WASHINGTON CITY
LAND USE AUTHORITY MEETING
STAFF REVIEW

HEARING DATE:	May 6th, 2026
ACTION REQUESTED:	Amended Preliminary Plat approval for the Desert Ridge Estates Phase 2-4 Subdivision, located at approximately Coyote Crest and Florence Drive
APPLICANT:	Brandee Walker
OWNER:	Stephen Howcroft
ENGINEER:	Civil Science
REVIEWED BY:	Eldon Gibb, Community Development Director
RECOMMENDATION:	Recommend approval with conditions onto city council

Desert Ridge Estates Phases 2-4

Amended Preliminary Plat

C1

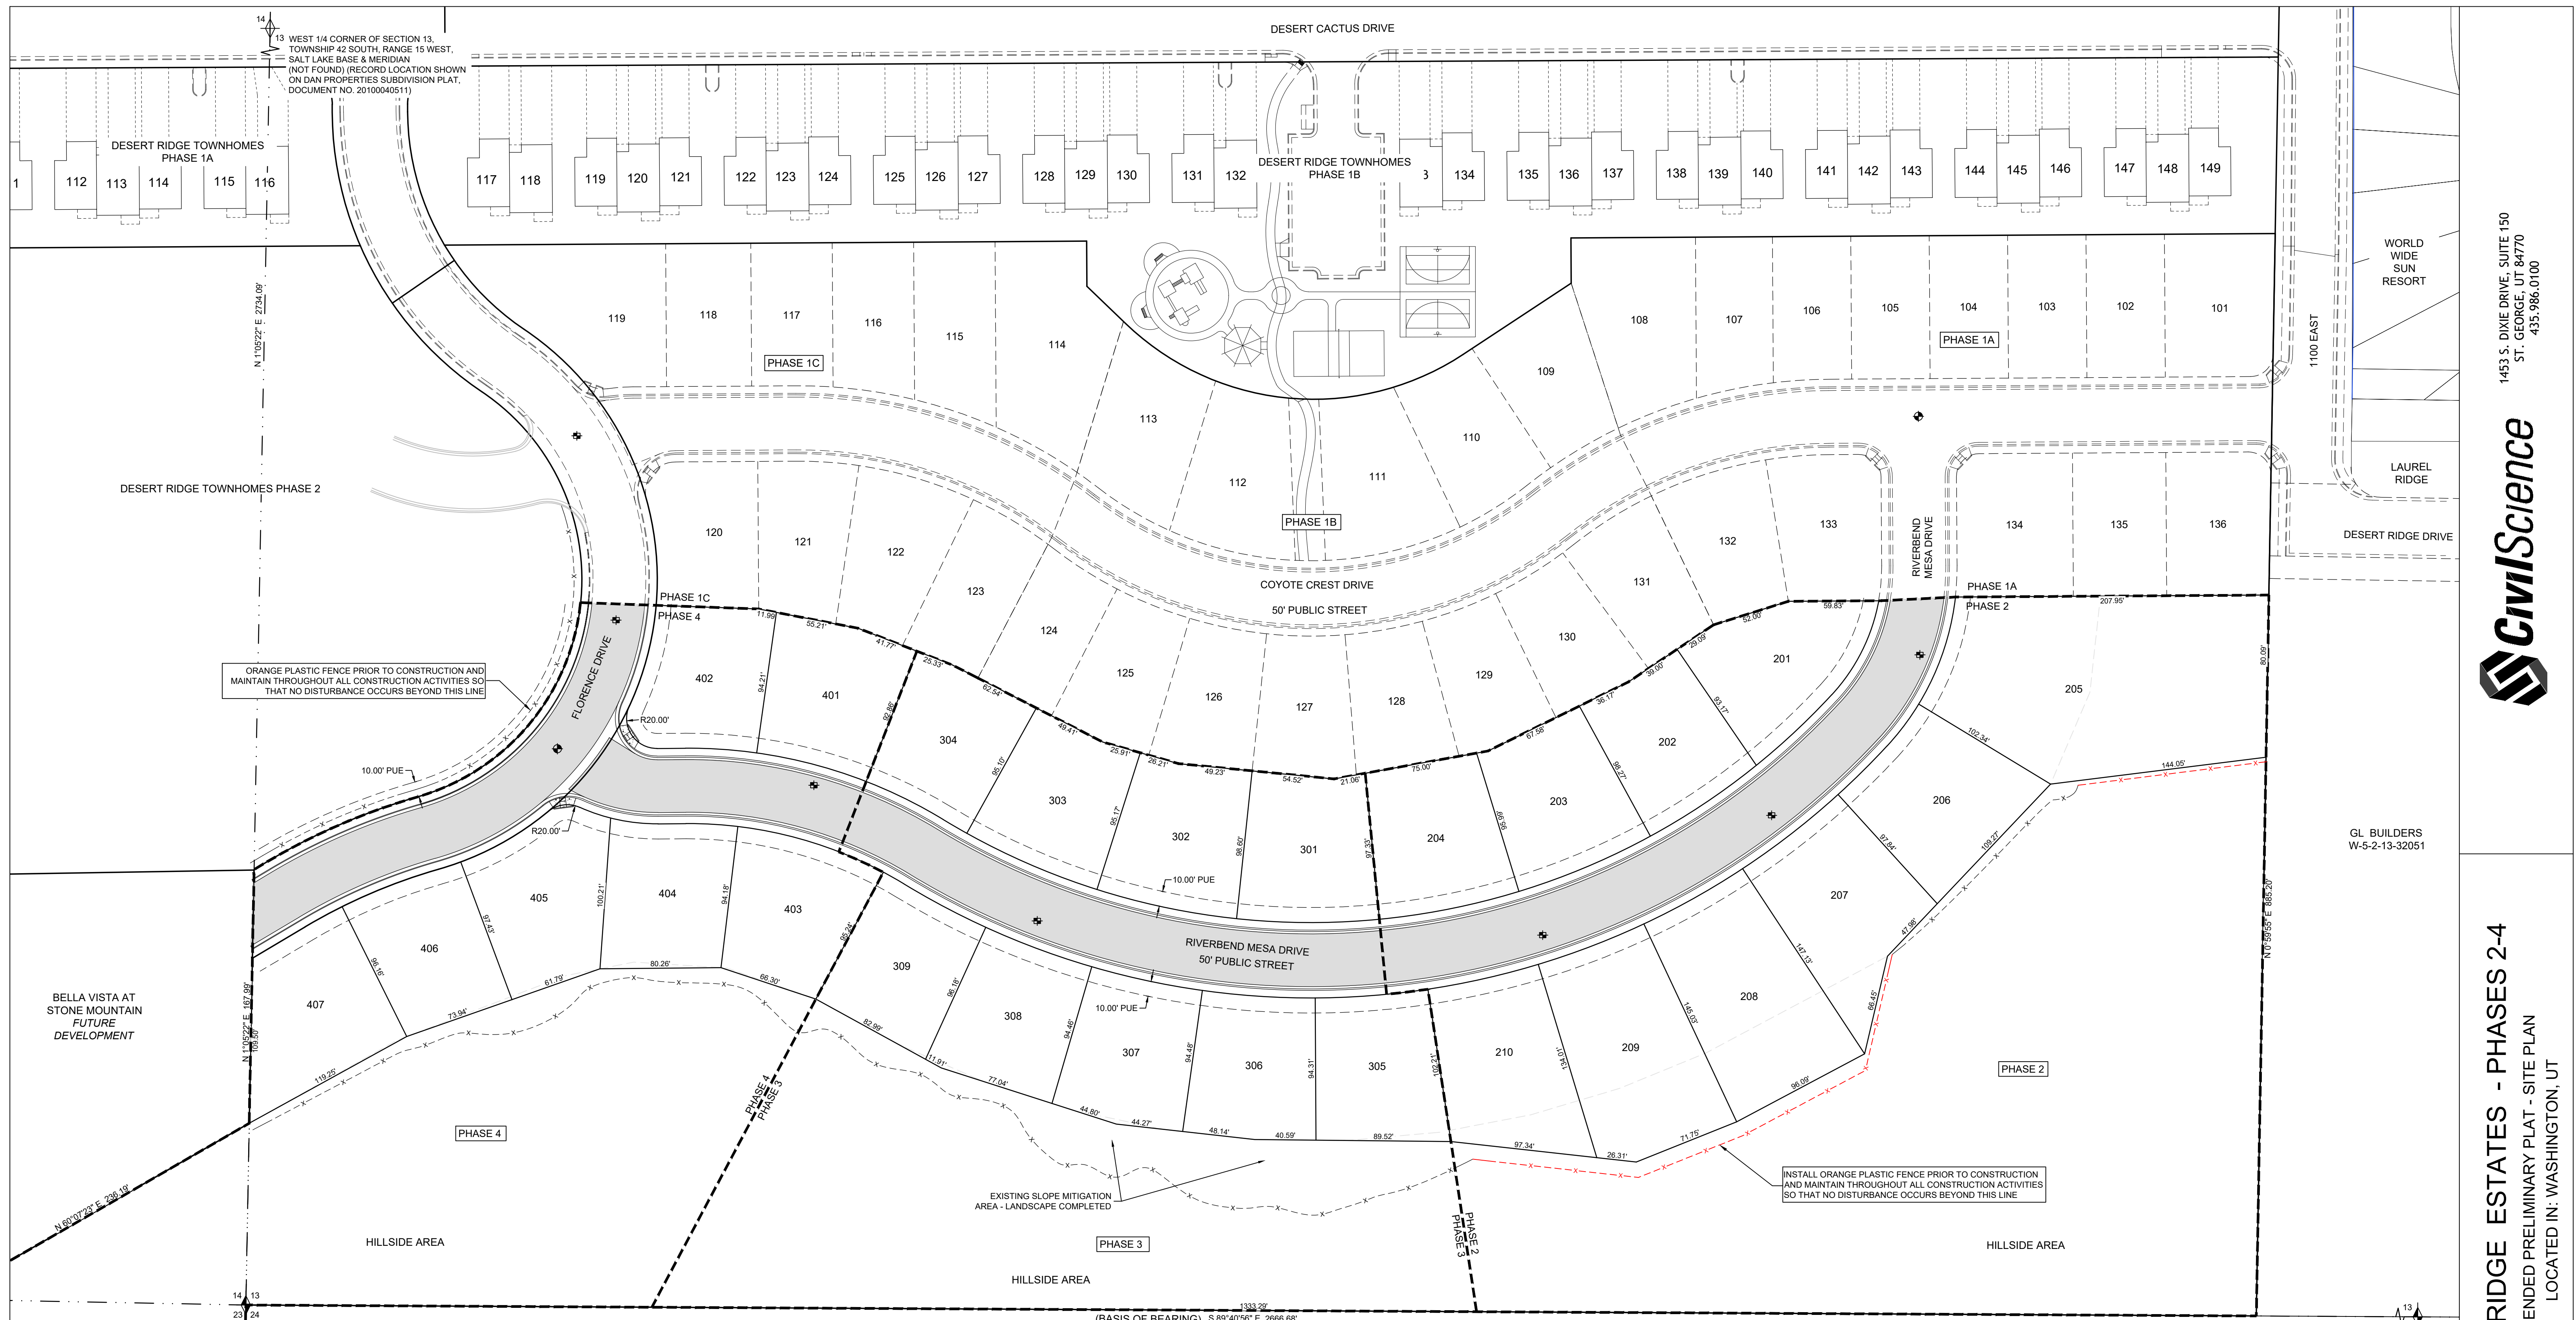
redline comments being made to conditions 13-24.

13. Lots ~~232, 233, 234 and 235~~ **205-209** shall be graded as shown in the exhibit to meet slope stability standards and reduce hillside cutting. A slope stability certificate report for these lots shall be submitted to planning/zoning with final plat application showing compliance

Condition 19: five lots must be single story and no more than two in a row. **(Council may want to consider referencing specific lot numbers and numerically identifying the height such as 25' feet tall max which applies to Lots 210, 305-309 and 403-407)**

Condition 24: ~~no buildable area will be allowed on the back of lots for structures on lots 215 through 234~~ Lots 208-210, 305-309, 403-407 shall not have any vertical structure in the area of the back yard area that is outside of the buildable envelope

13. Lots 205-209 shall be graded as shown in the exhibit to meet slope stability standards and reduce hillside cutting. A slope stability certificate report for these lots shall be submitted to planning/zoning with final plat application showing compliance

19. Five lots of the following 11 lots (210, 305-309 and 403-407) shall consist of single story homes no taller than 25' feet and no more than two in a row.

24. Lots 208-210, 305-309, 403-407 shall not have any vertical structure in the area of the back yard area that is outside of the buildable envelope

DESERT RIDGE ESTATES
DISTURBANCE & MITIGATION EXHIBIT
LOCATED IN: WASHINGTON, UT

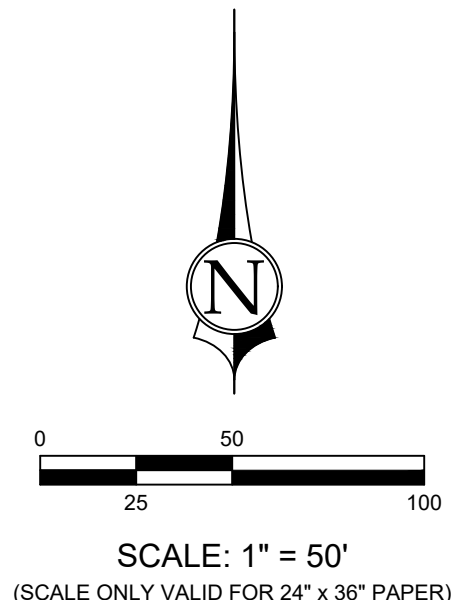
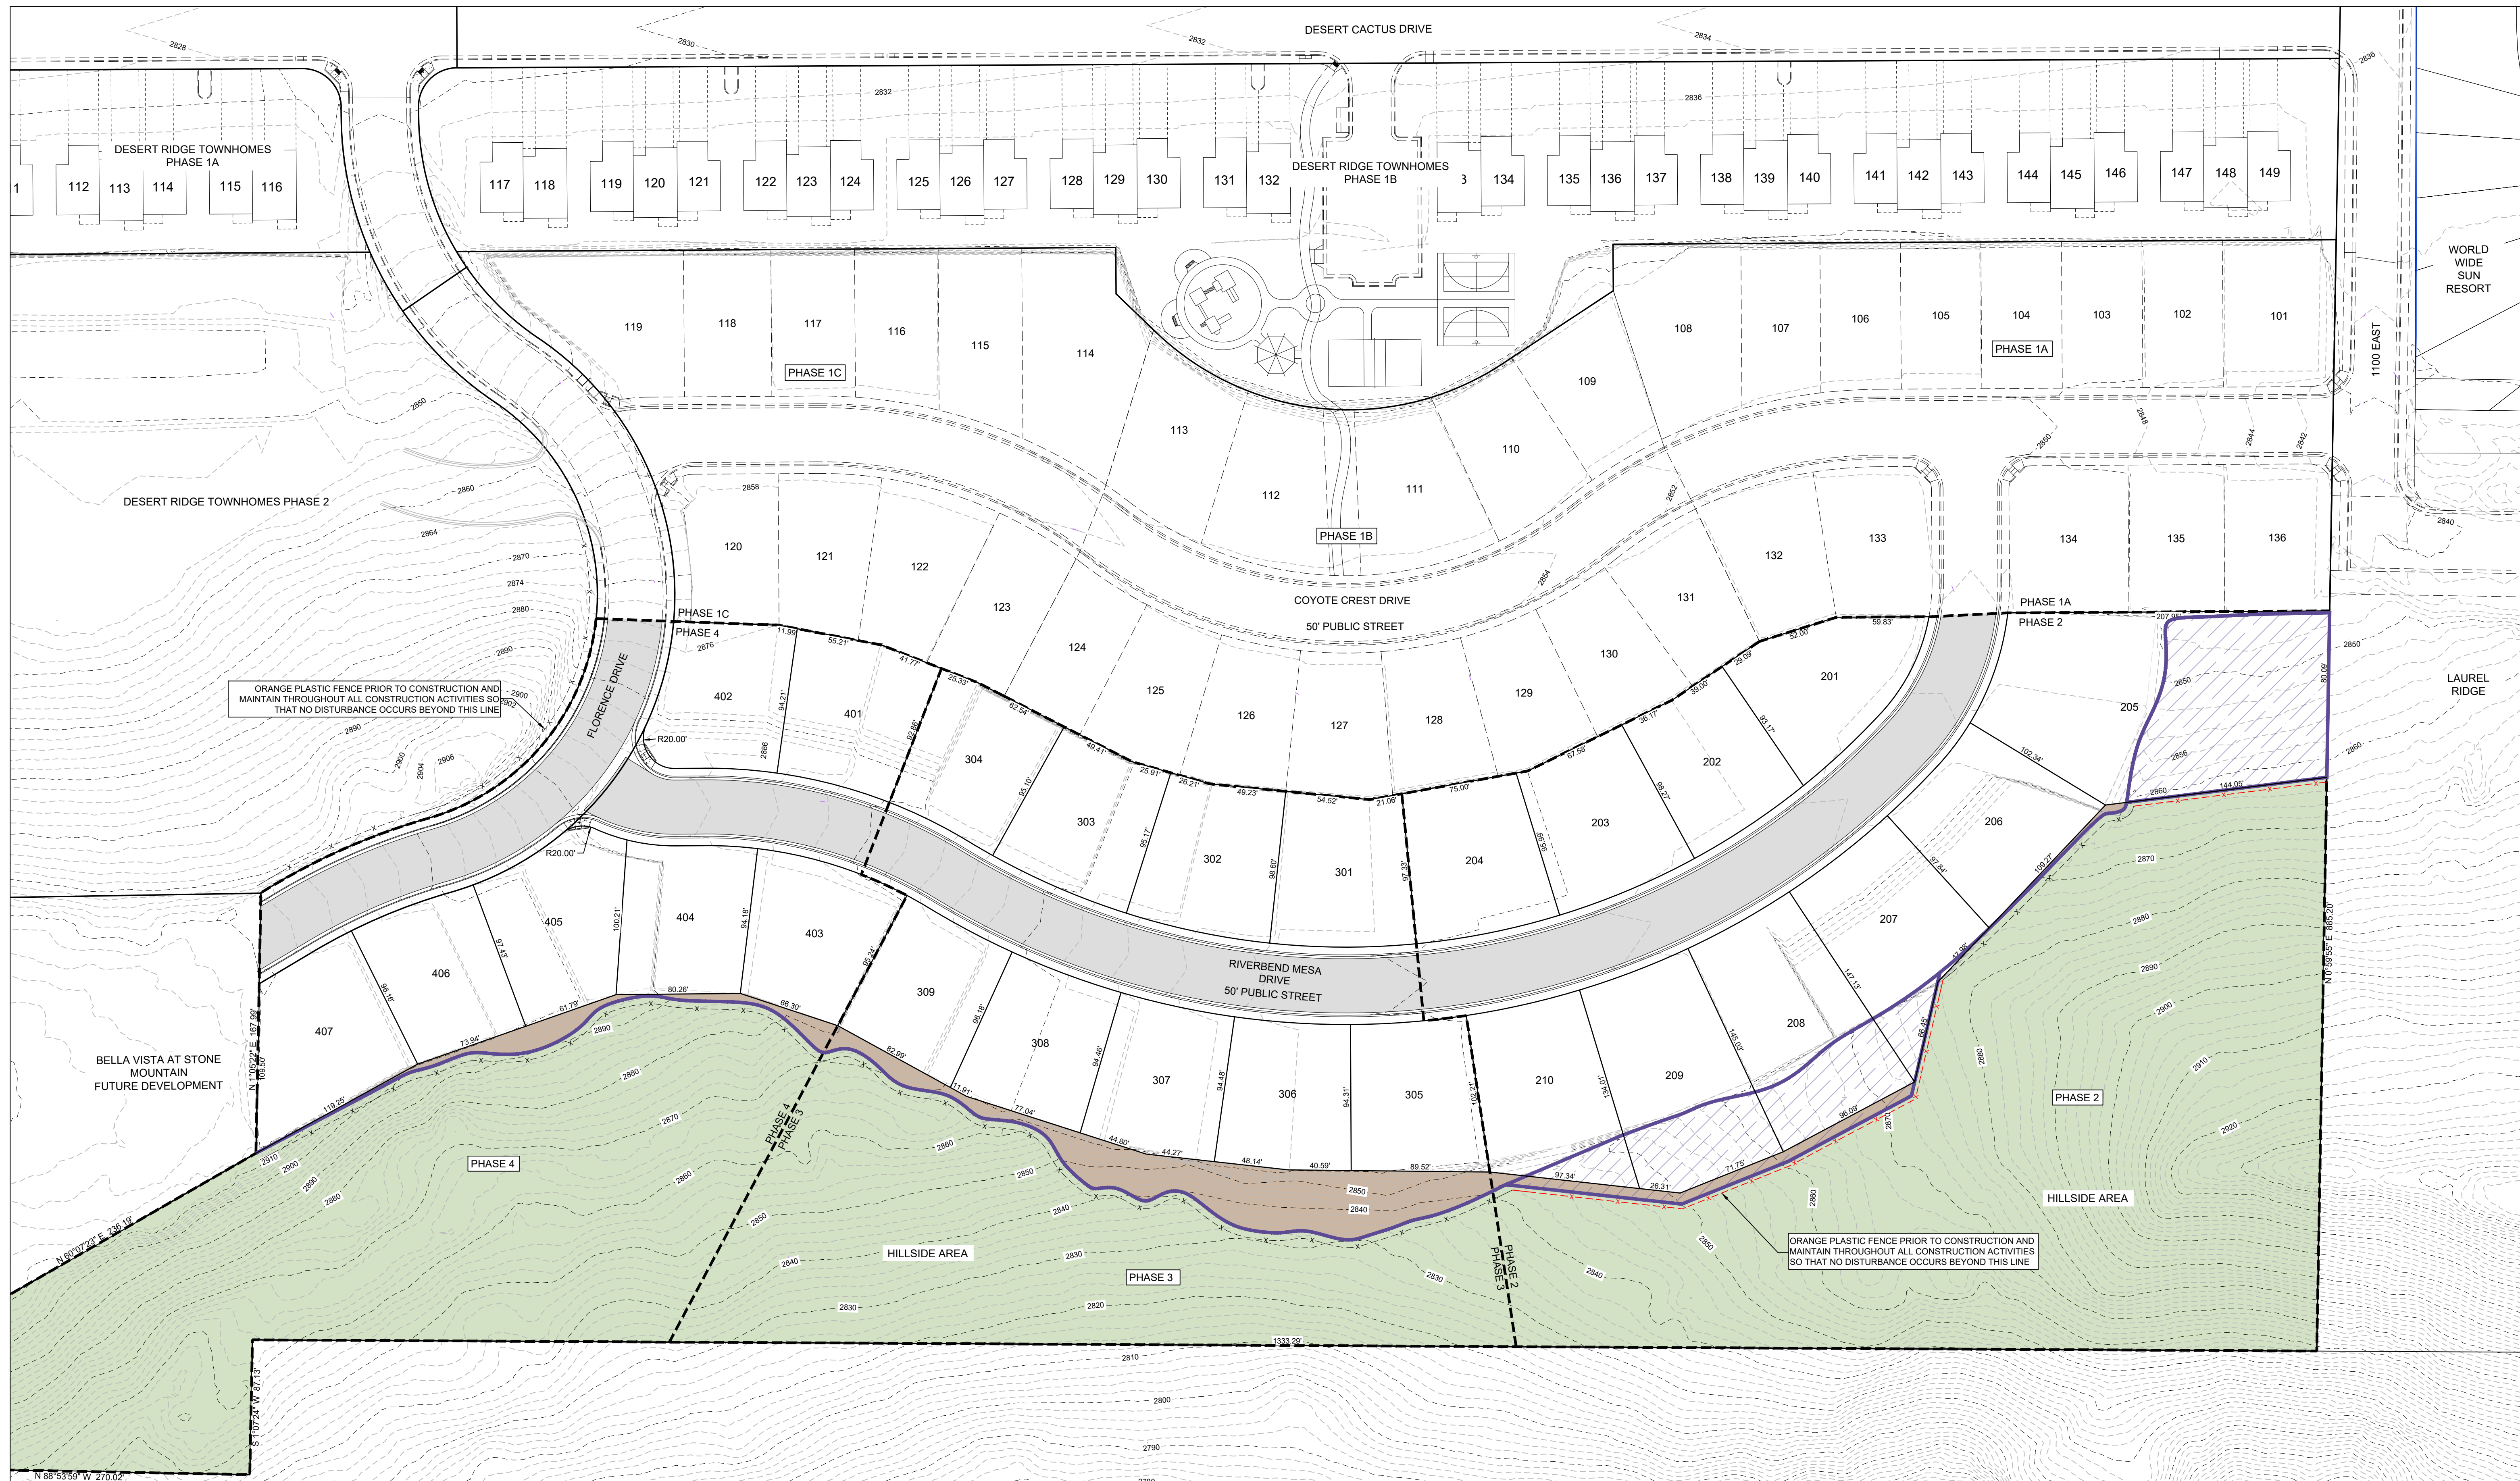
15. A No Disturbance fence shall be installed **at/or within the no disturb limit** as shown in the exhibit ~~behind lots 215 through 236 and 135 / 136~~ **(lots 205-210, 305-309, 403-407)** to ensure this open area remains undisturbed. This No Disturbance fence shall be maintained, monitored and strictly enforced throughout construction on this site. The no disturbance fence shall be orange plastic fence and approximately 36" inches tall.

16. A No Disturbance fence shall be installed on the west end of Florence Drive running north to south all along this development and tying into the no disturb fence south of lot ~~215~~ **407** to ensure the hillside area between Florence Drive and Bella Vista Drive remains undisturbed. This No Disturbance fence shall be maintained, monitored and strictly enforced throughout construction on this site. The no disturbance fence shall be orange plastic fence and approximately 36" inches tall.

17. Prior to final plat application, all of the grading disturbance areas (purple shading) identified in the open space area ~~on page C10~~, shall be restored with rockery walls and planted / hydroseeded material that is native to the area. There shall be no hillside scarring visible and all restoration efforts shall be complete.

15. A No Disturbance fence shall be installed at/or before the no disturb limit as shown in the exhibit behind lots 205-210, 305-309, 403-407 to ensure this open area remains undisturbed. This No Disturbance fence shall be maintained, monitored and strictly enforced throughout construction on this site. The no disturbance fence shall be orange plastic fence and approximately 36 inches tall.

16. A No Disturbance fence shall be installed on the west end of Florence Drive running north to south all along this development and tying into the no disturb fence south of lot 407 to ensure the hillside area between Florence Drive and Bella Vista Drive remains undisturbed. This No Disturbance fence shall be maintained, monitored and strictly enforced throughout construction on this site. The no disturbance fence shall be orange plastic fence and approximately 36 inches tall.

17. Prior to final plat application, all of the grading disturbance areas (purple shading) identified in the open space area shall be restored with rockery walls and planted / hydroseeded material that is native to the area. There shall be no hillside scarring visible and all restoration efforts shall be complete.
